22500 Salamo Road
West Linn, OR 97068

STAFF REPORT FOR THE PLANNING COMMISSION

FILE NUMBER: DR-13-02

REQUEST: Class II Design Review for expansion and remodel of existing gas station building, conversion of the portion of the building from automotive service to convenience sales, and associated landscaping and parking changes.

SHEET
 A3.1

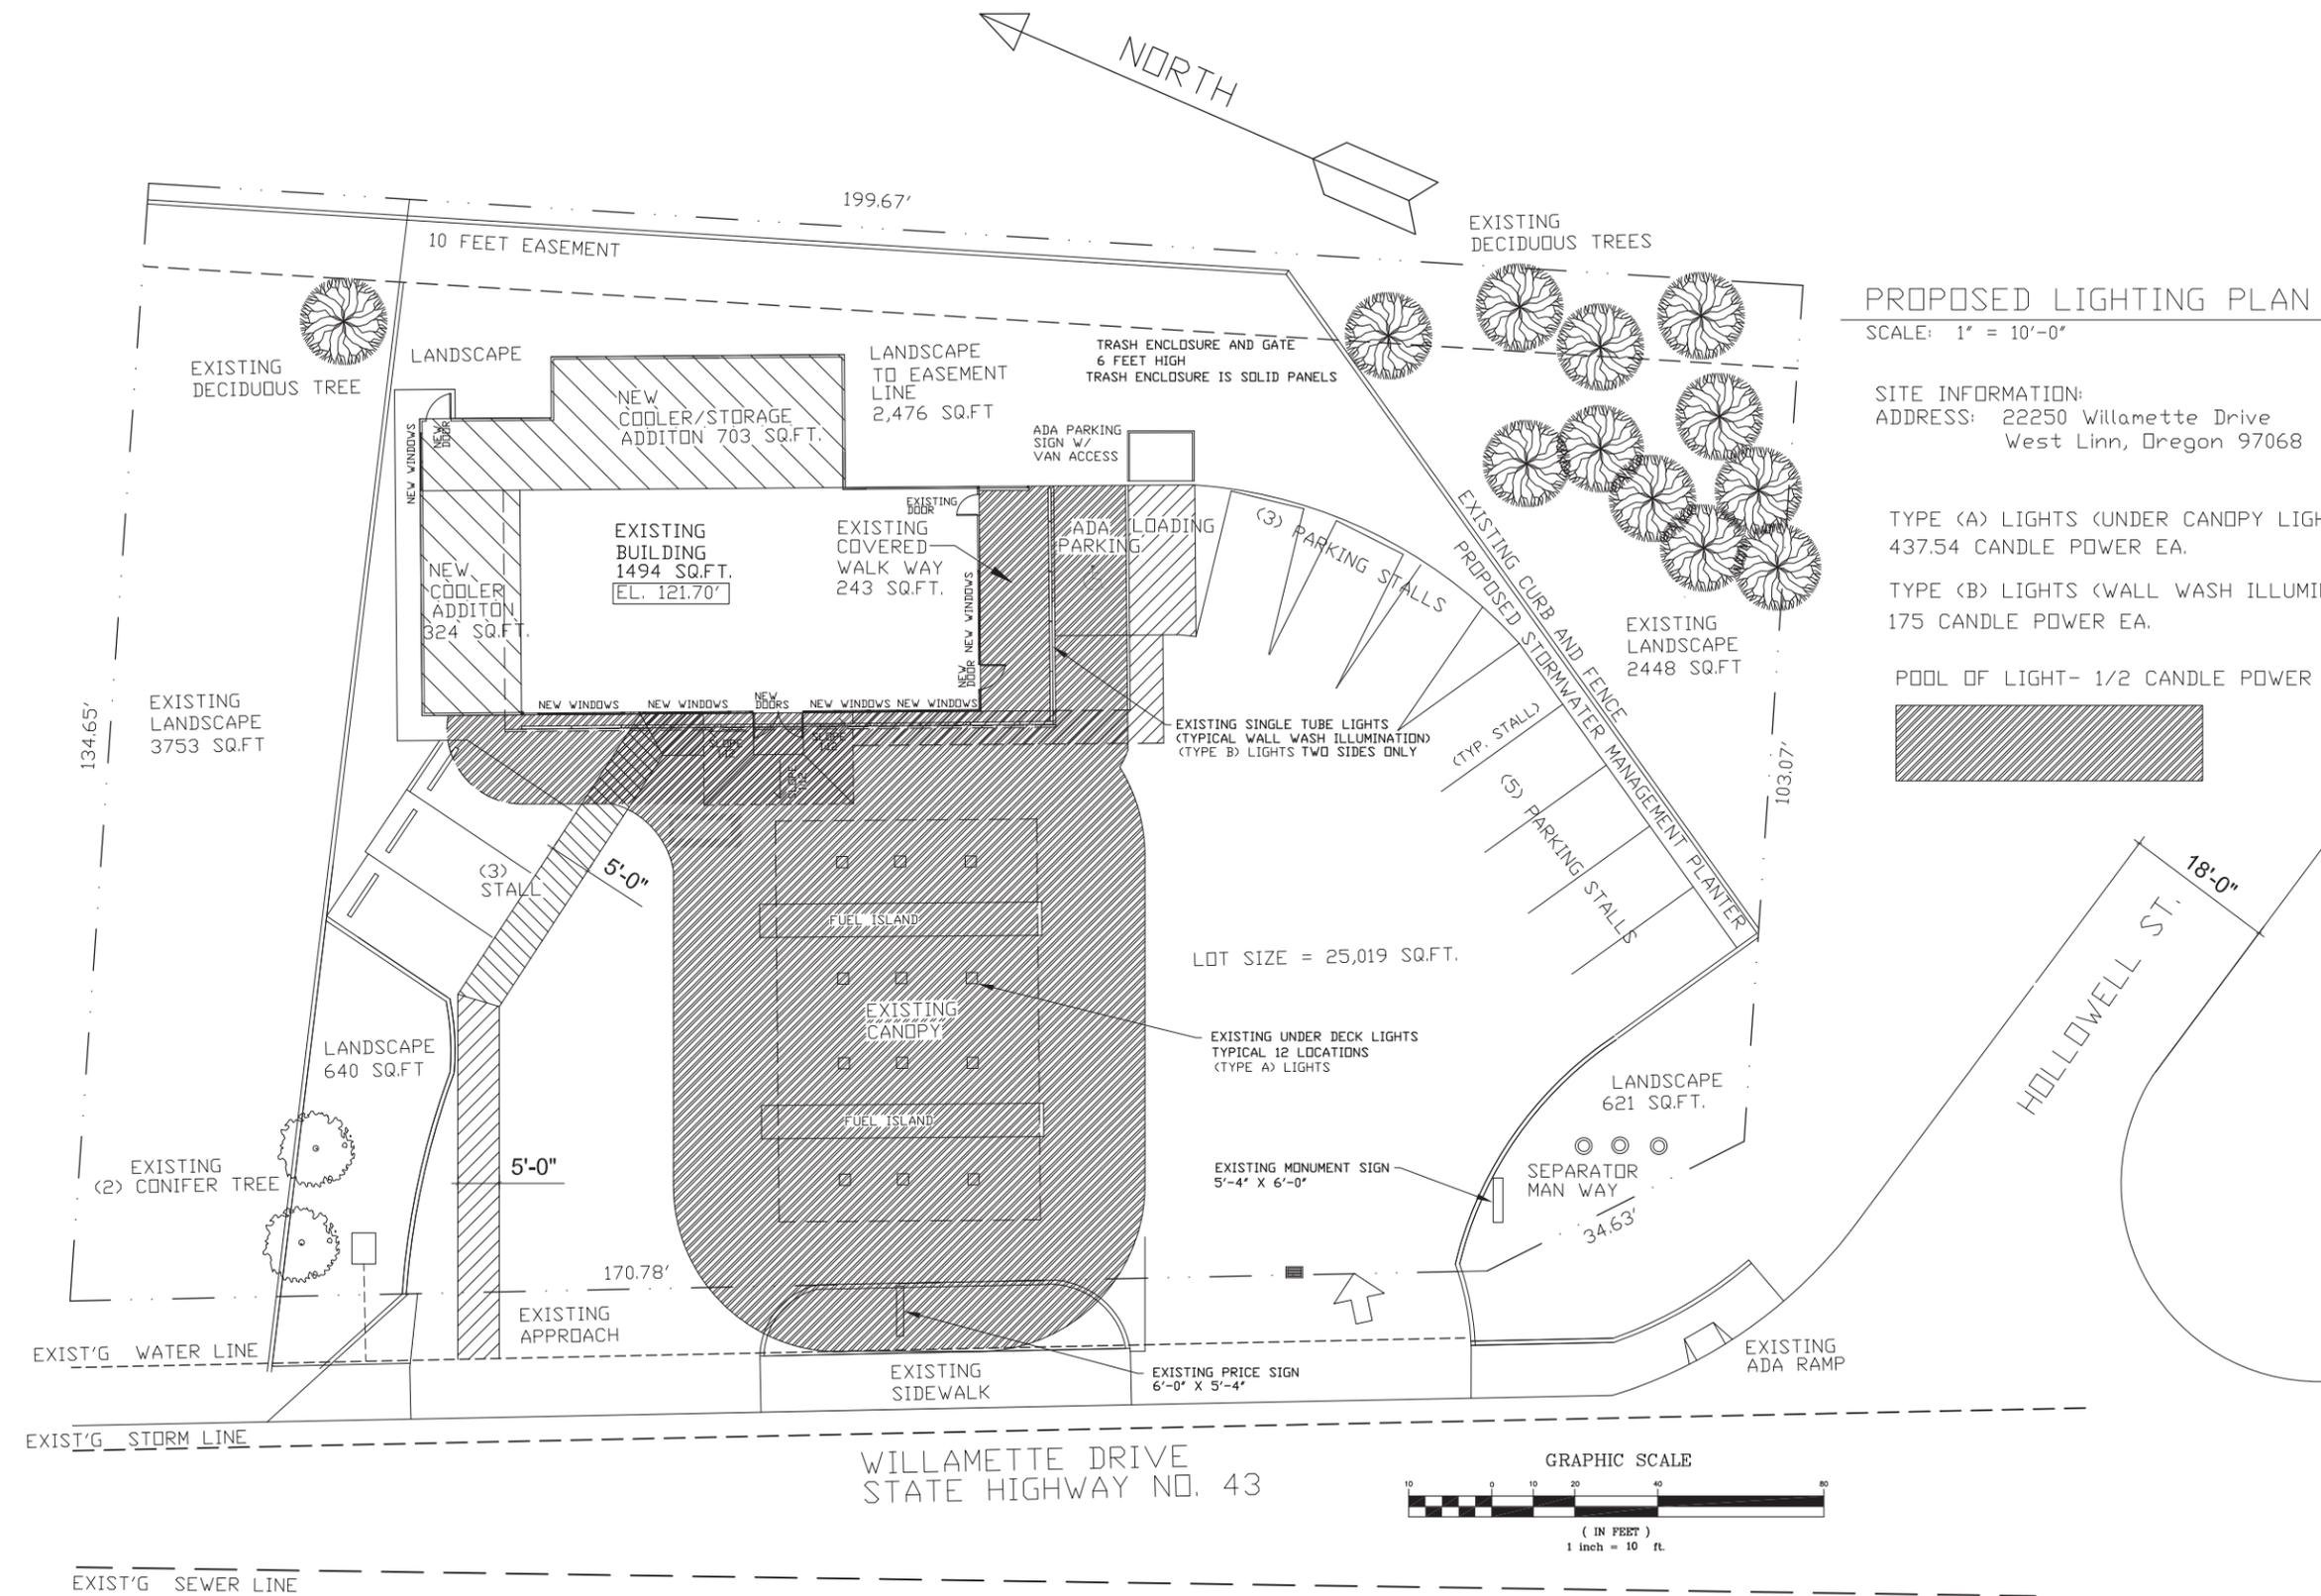
Staff Response 13: Due to the conversion of some paved areas to landscaping, impervious surfaces on site are actually being reduced, so establishment of separate stormwater treatment and detention facilities is not required. Staff determines the criterion is met.

SHEET
 A3.2

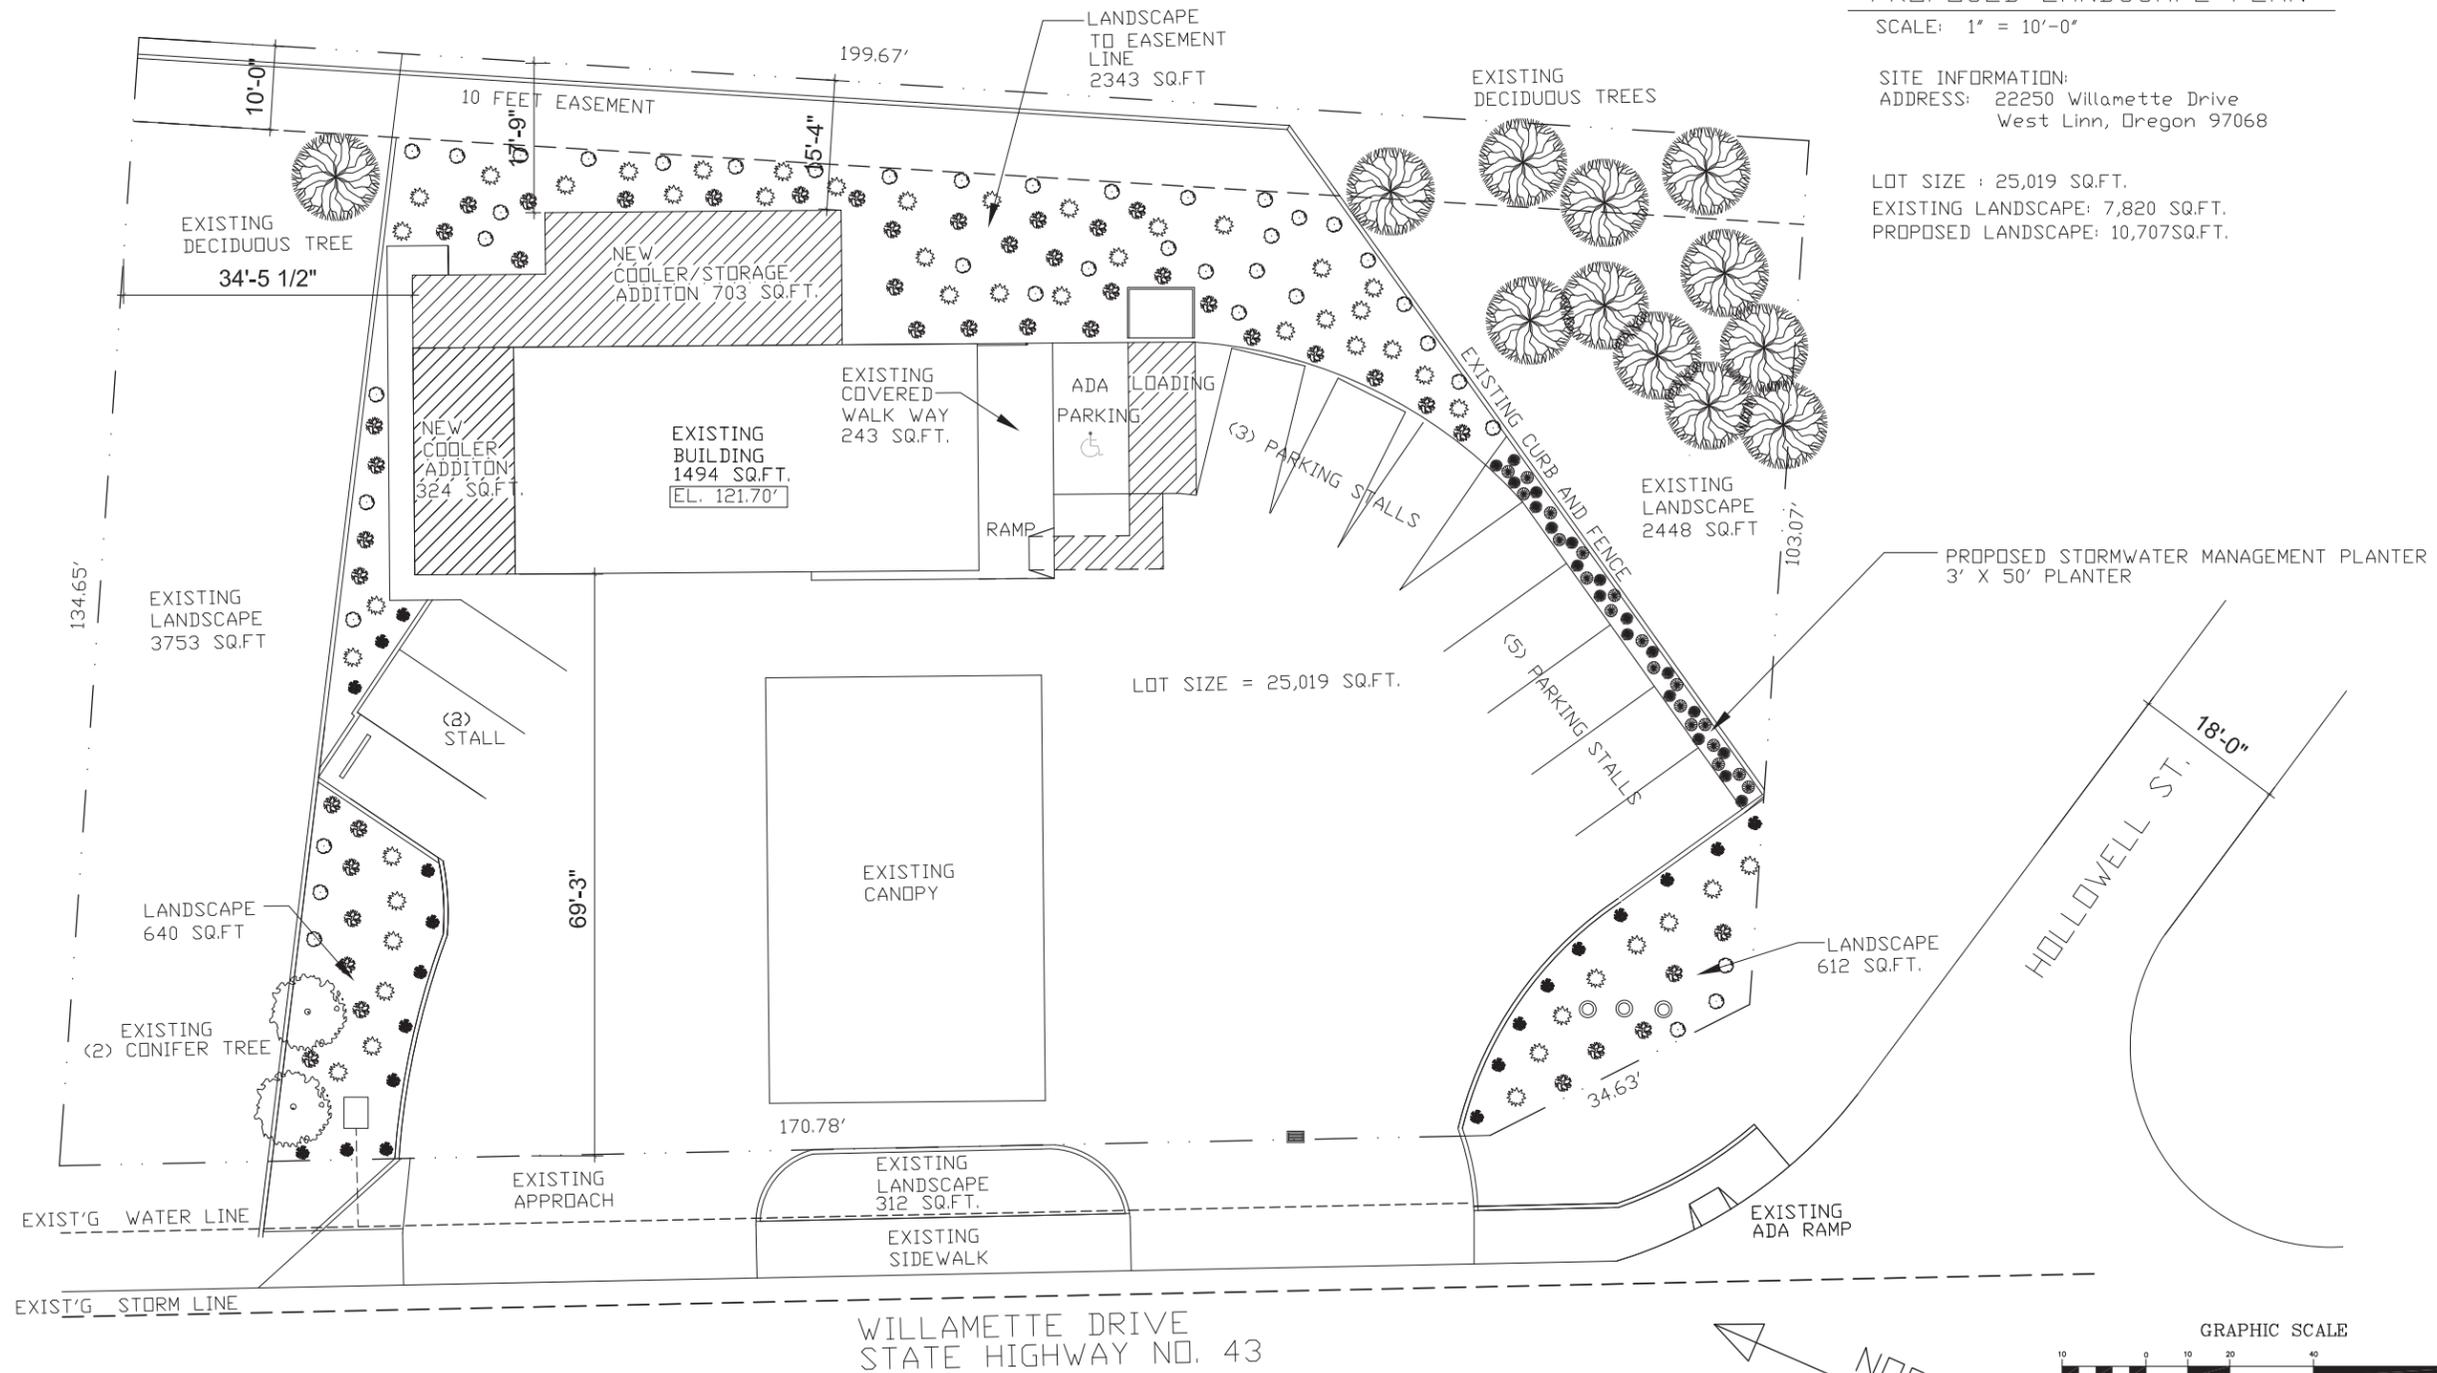
Subsections 55.200(J)(3-5) require lighting to illuminate heavily trafficked and potentially dangerous areas such as pedestrian walkways, parking areas, and the waste/recycling area. The applicant’s Proposed Lighting Plan on Sheet A3.2 on Page 76 of Exhibit PC-4 does not include many of these areas in the “pool of light”. Condition of Approval 7 is recommended so lighting covers all of these areas (See Staff Response 93).

Staff Response 93: No mailboxes are proposed. The waste/recycling area is proposed just outside the area covered by the lighting plan as seen on Sheet A3.2 Proposed Lighting Plan on Page 76 of Exhibit PC-4. As also seen on this plan there are also sections of the parking lots and proposed pedestrian walkway that will not be covered by the “pool of light”. Condition of Approval 7 requires extra lighting be installed to cover these areas, without affecting nearby residential properties. Staff finds that the criterion is met upon the inclusion of Condition of Approval 7.
